ATCO Gas Australia Midwest and Southwest Gas Distribution
System

REVIEW OF SELECTED ASPECTS OF ATCO'S REVISED PLAN FOR AA6

Report prepared for:
**ECONOMIC REGULATION
AUTHORITY WESTERN
AUSTRALIA**
October 2024

Figure 3.1: ATCO’s revealed costs for B2 and B3 connections (\$, real 2023) – no overheads

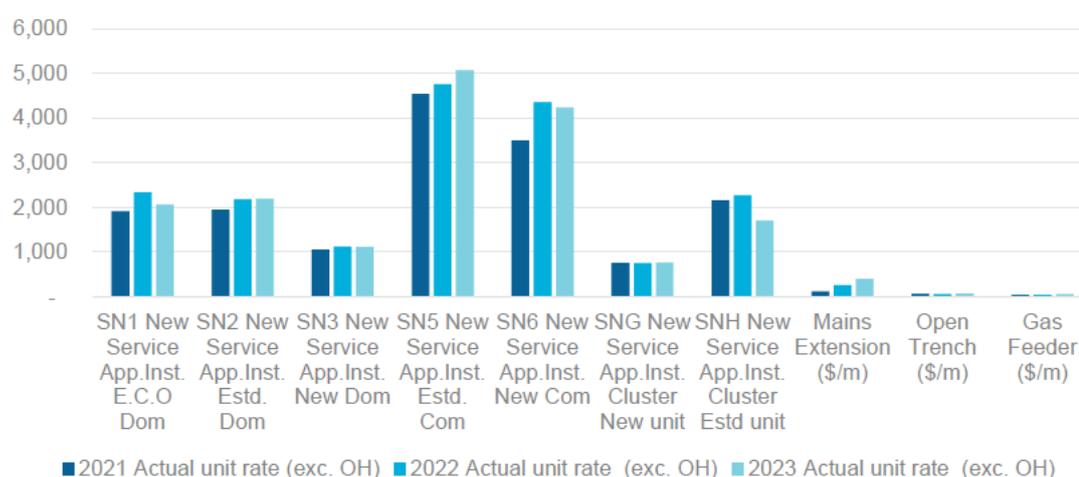
180. We note the steady increase in SN5 unit costs from 2021-2023 in Figure 3.1 which seems to contradict the variability of Brownfield connection costs referred to by ATCO. We consequently examined the volume fluctuation in each of the three years from 2021-2023. There is no pattern to suggest that the volume of work is a material factor in the annual cost trend.⁷² SN5 work constitutes 1.7% of the projected \$144.7 million connections expenditure, so the relative impact of the cost increases is minor.
